Product Change Notification

1. **ECN #:** 261058

- BNC7T - TRUE 75 OHM, BNC STR JACK SHELL

Existing & New Design (Rear View)

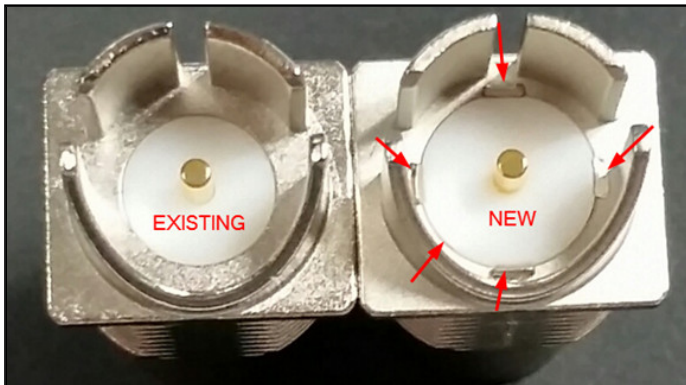
Four tabs were added to the PCB termination area of the connector to increase retention on the white insulator during reflow heat. The diameter of the insulator increases from 7.32mm to 7.48mm.

The new revision of material will have 4 bent tabs equally spaced on the rear of the connector. The diameter of the insulator material from the rear of the connector will measure an estimated 7.48mm.
